Subject: Borel Middle School HVAC Replacement
San Mateo - Foster City School District
Aedis Project No. 2021005
DSA Application #01-119557

ADDENDUM NO. 1

SHEET # AD1-
A5.01

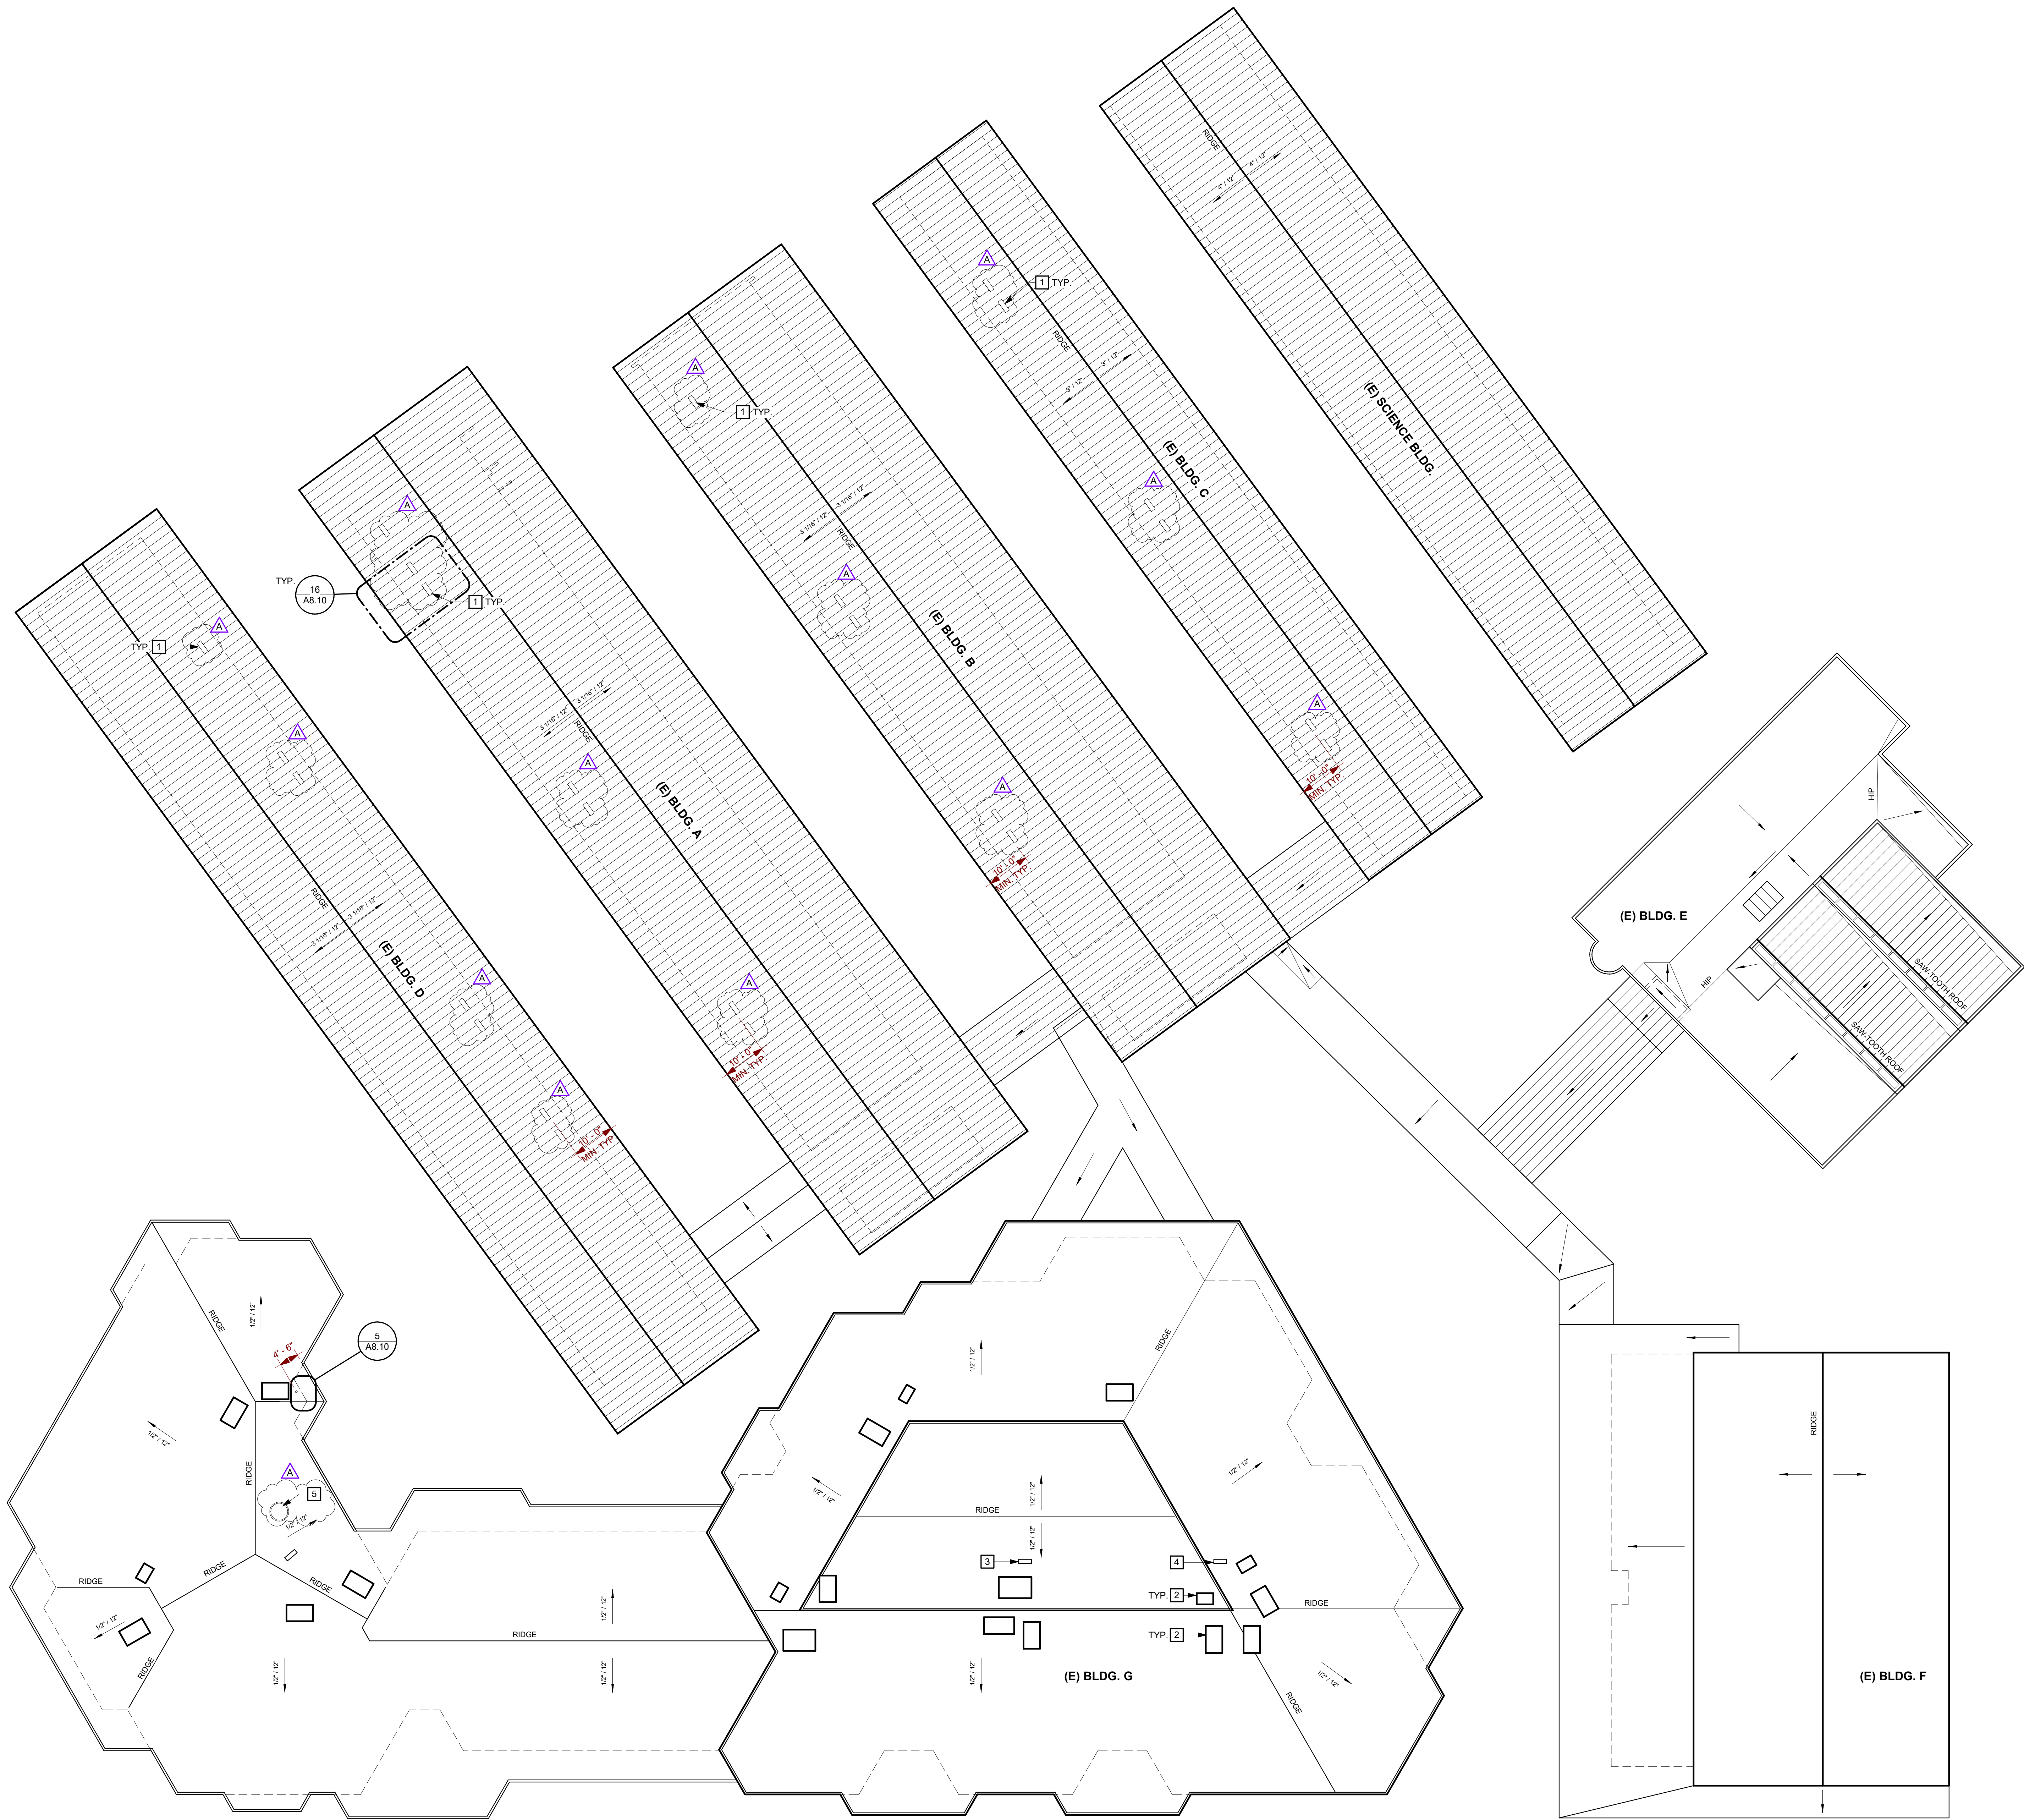
- Add: Exhaust fan per AD1-A5.01
- Revise: Mechanical platform graphic per AD1-A5.01
- Revise: Roof Plan Keynotes #1 and #2 per AD1-A5.01
- Add: Roof Plan Keynote #5 per AD1-A5.01

1 WALL TYPE 1 - MECH. ENCLOSURE
SCALE: 1 1/2" = 1'-0"

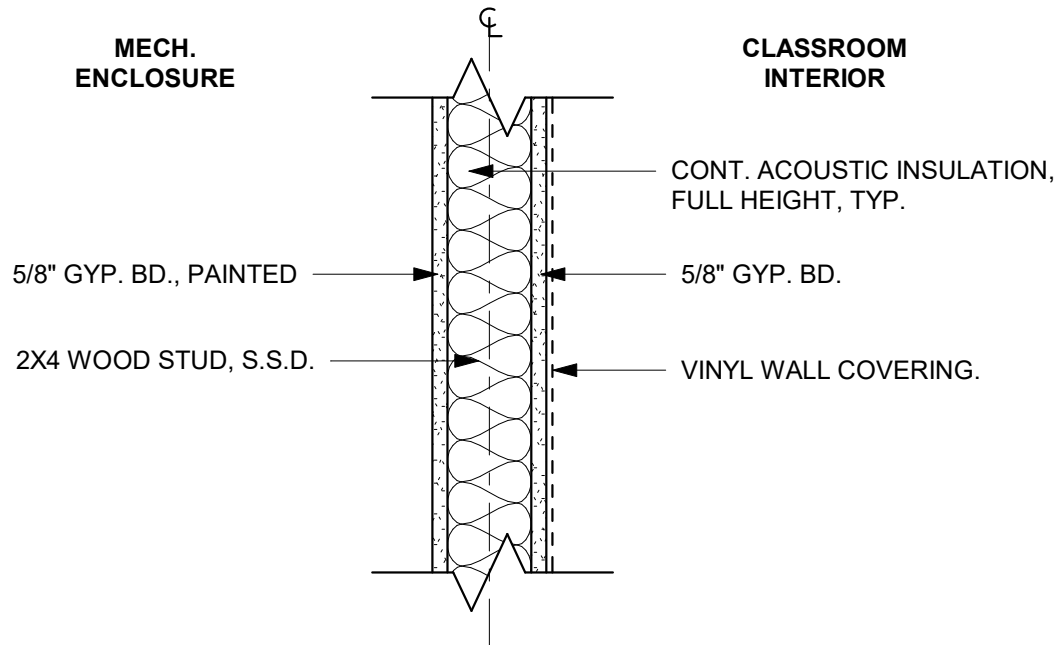
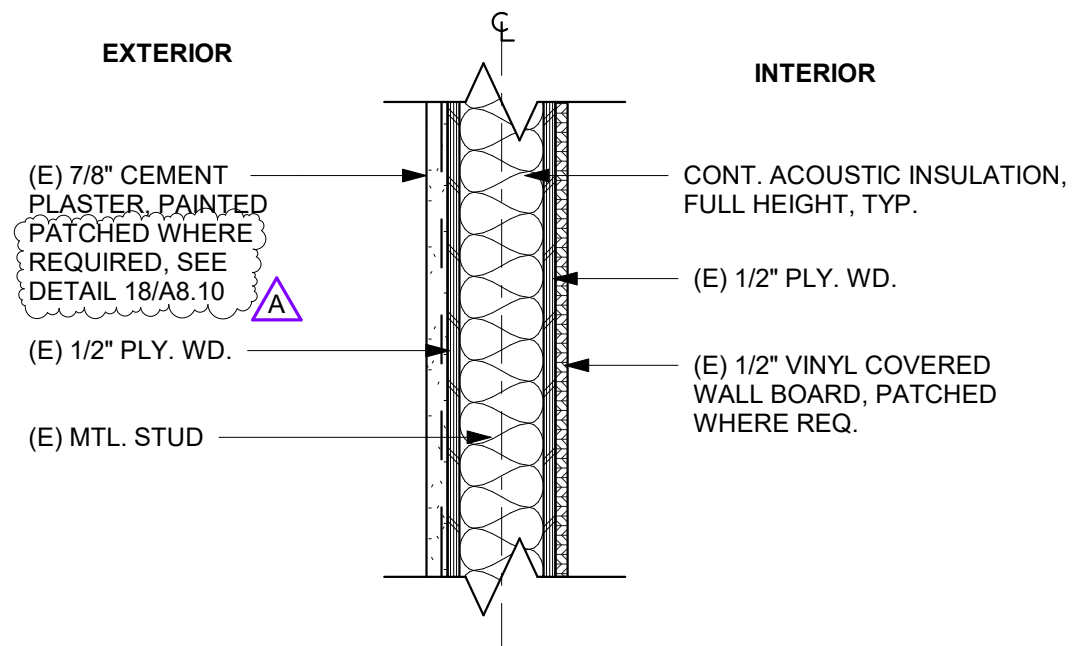
- Revise: Details 1 & 3 per AD1-A9.10A
- Revise: Detail 6 per AD1-A9.10B

SHEET # AD1-
MP2.01

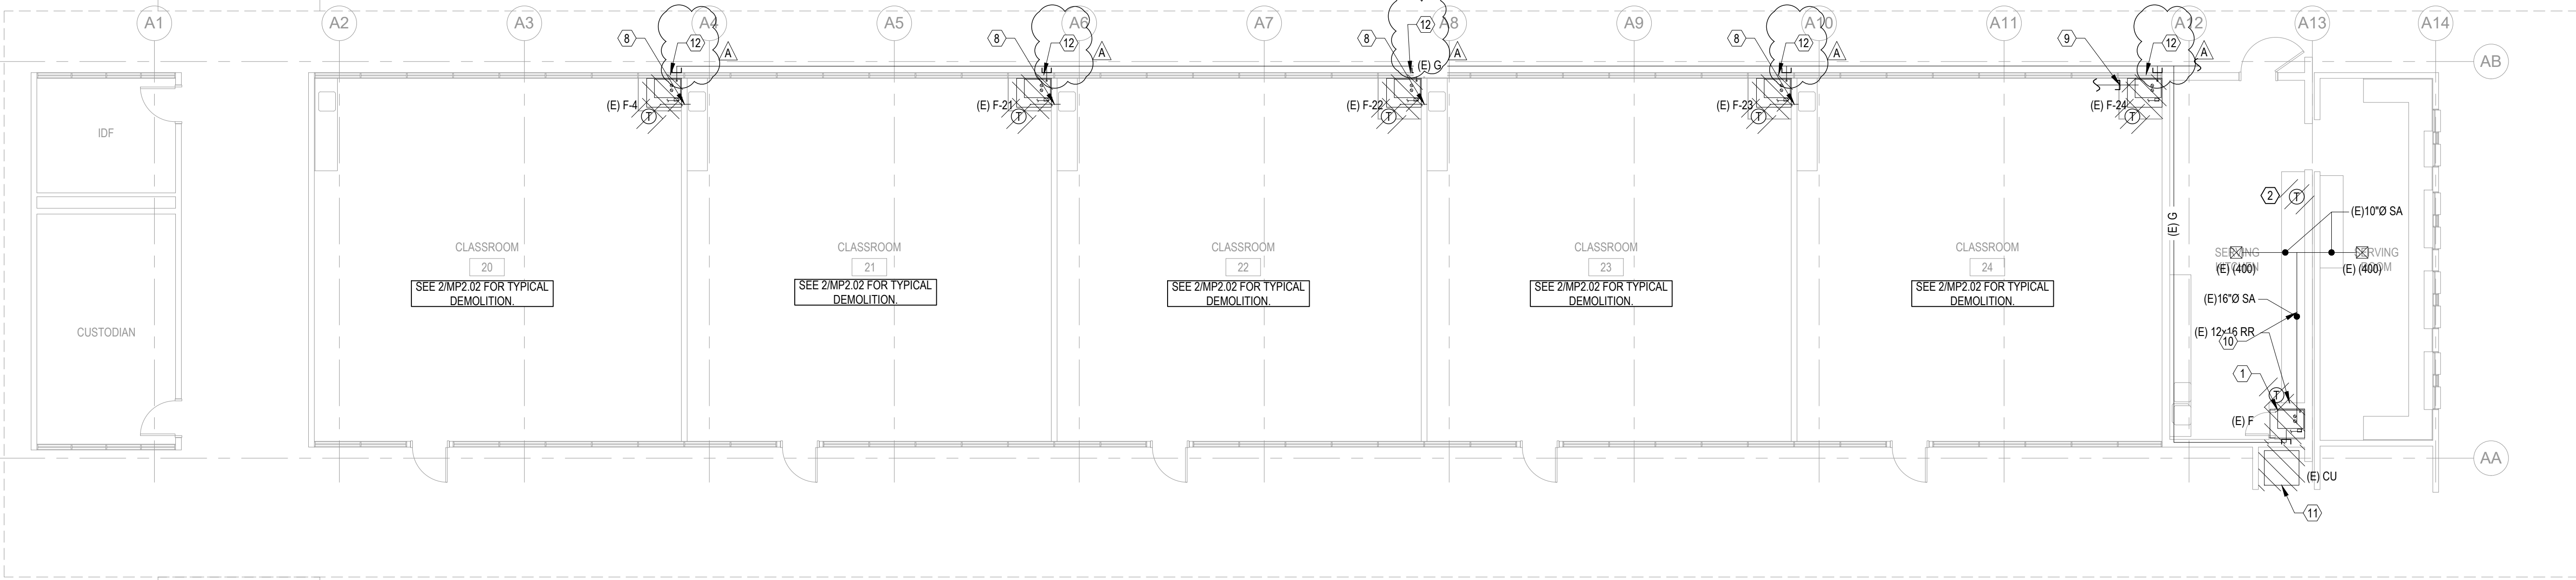
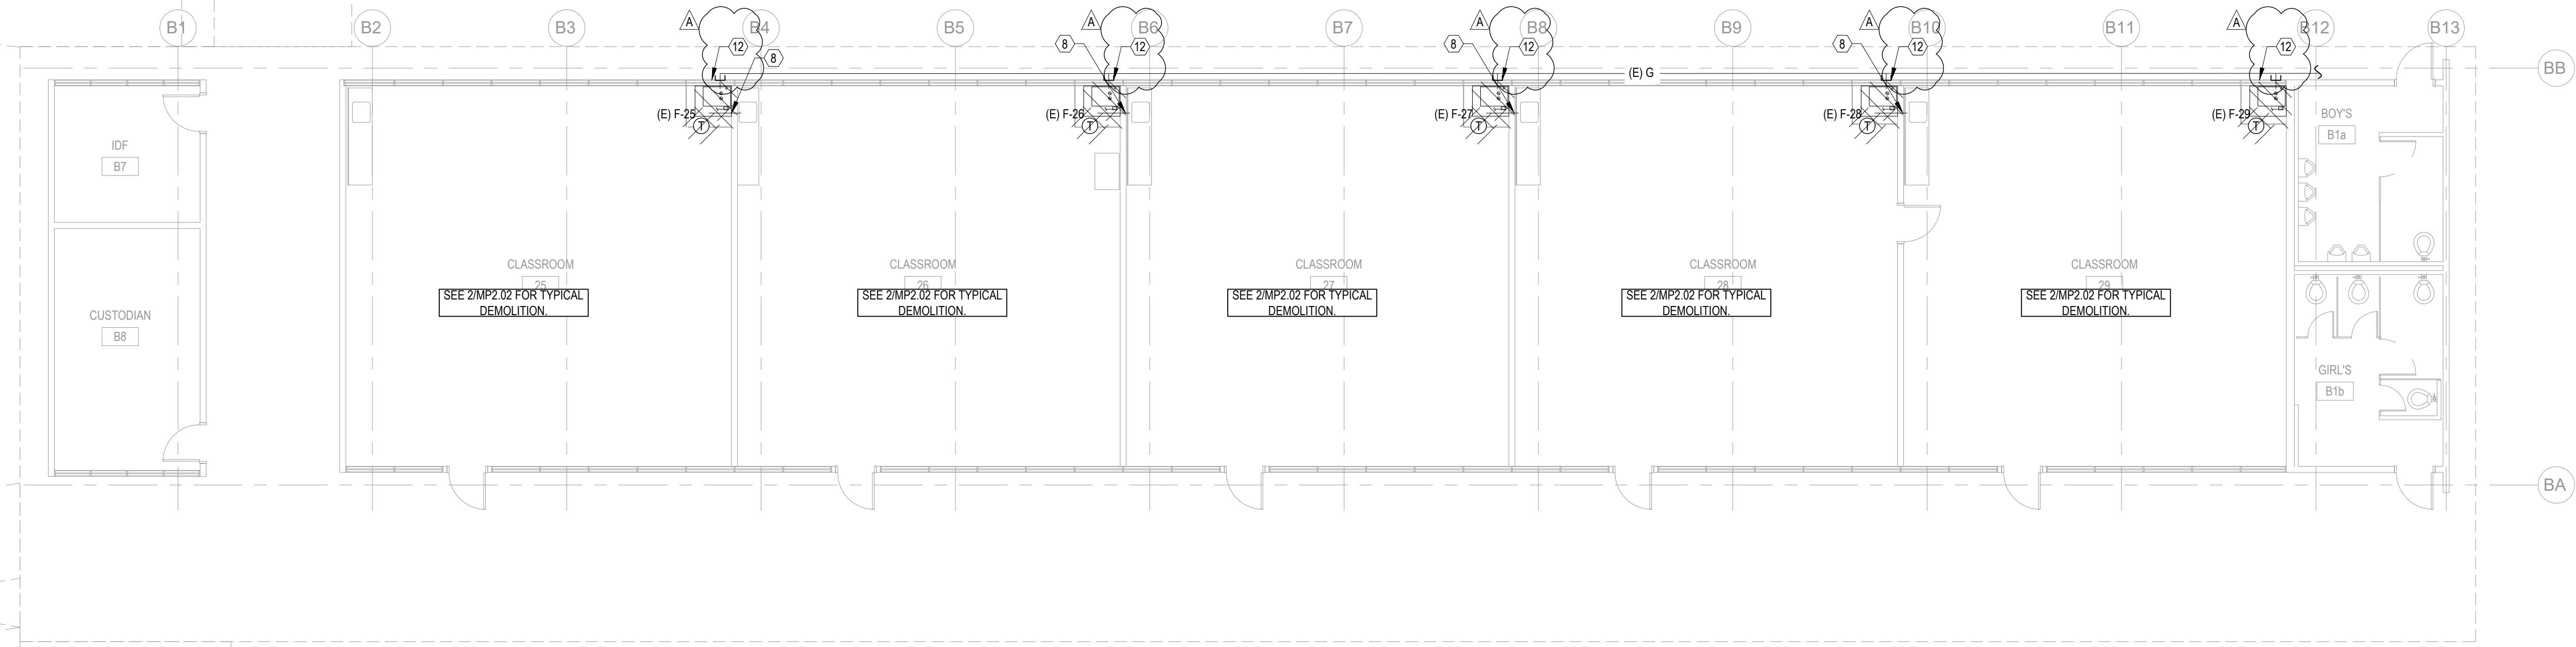
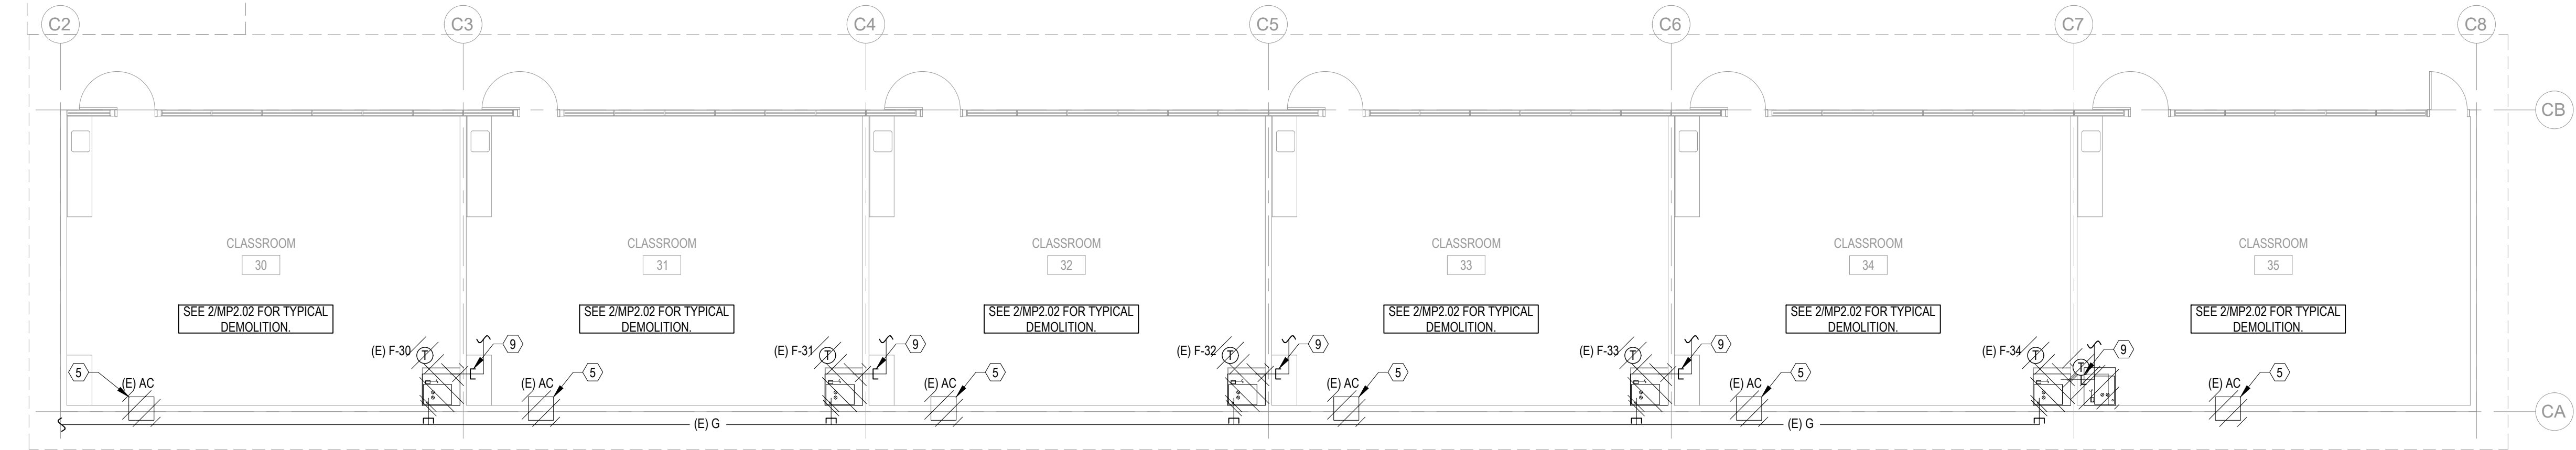
Add: Cap Bottom Louver per AD1-MP2.01

Add: Demolition Sheet Notes #12 per AD1-MP2.01

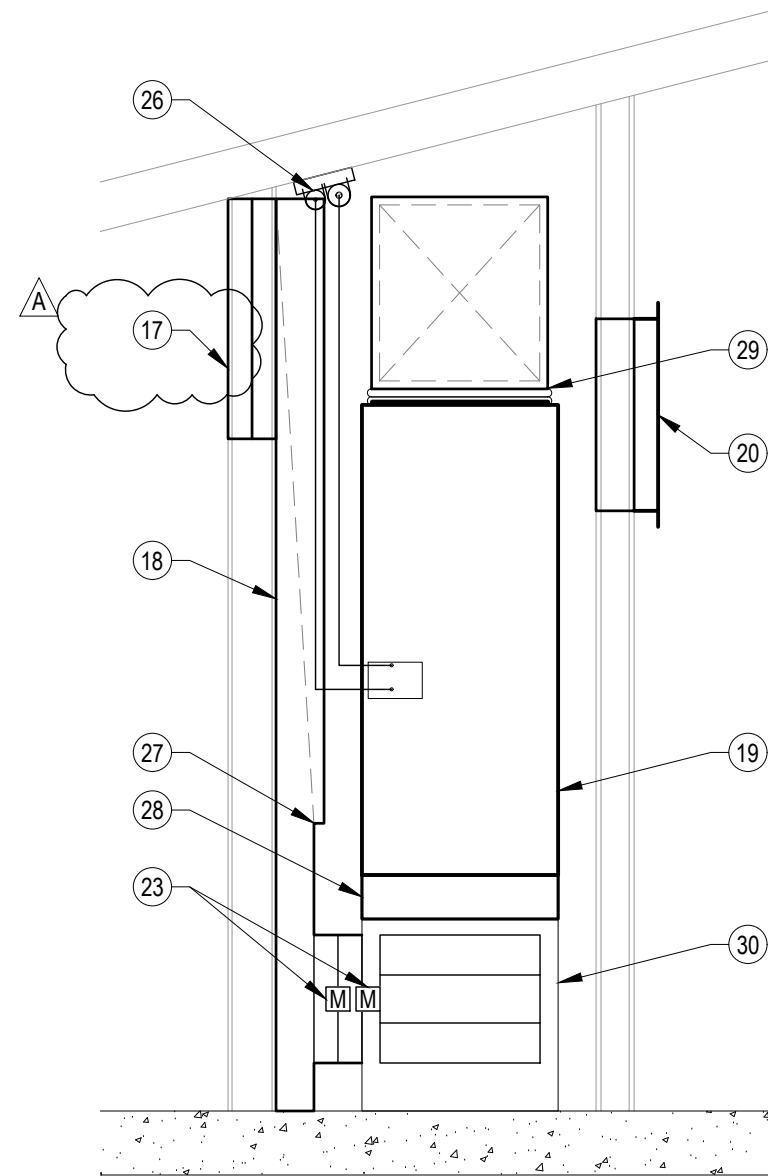
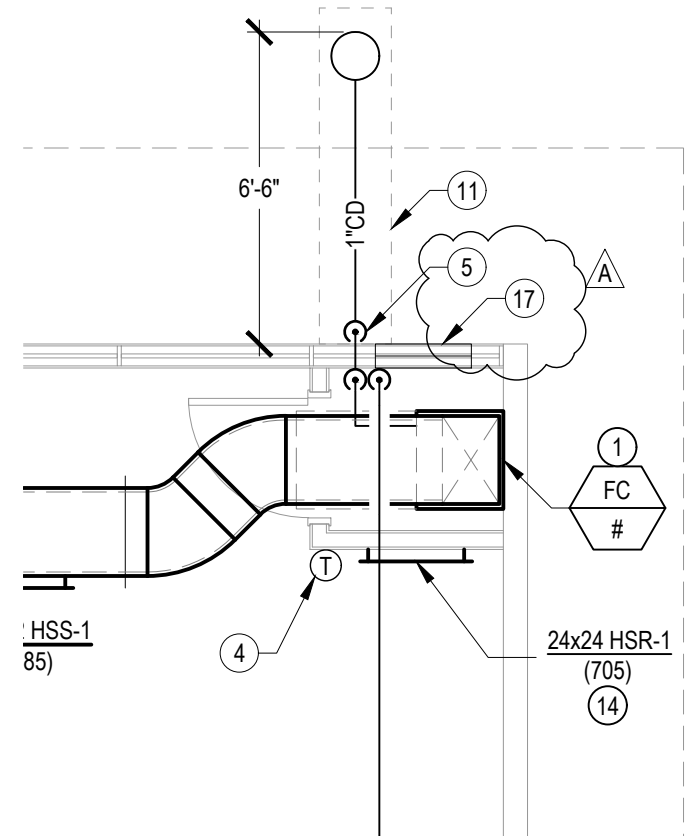
Revise: General note #5 per AD1-MP2.05a

Add: General note #10 per AD1-MP2.05a

Add: Dimension per AD1-MP2.05a.
